SERVICE BULLETIN

PAPER MACHINERY CORPORATION

180424
PAPER CLAMP UPGRADE
255.1

HS-800

8001749 ASSY,RETRO,SPLICE TABLE,TOP,HS-800

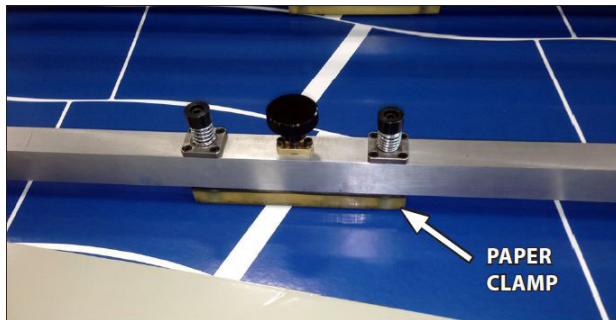
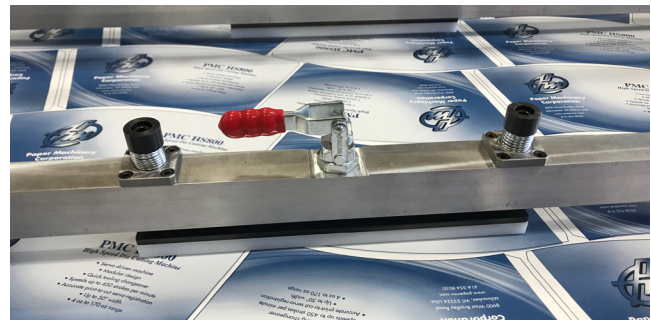
Paper Machinery Corporation has made improvements to the Paper Clamp on the splice table. The original design used a threaded knob to clamp and hold the paper in place while splicing. The new design uses a toggle clamp, reducing the time required to clamp the paper.
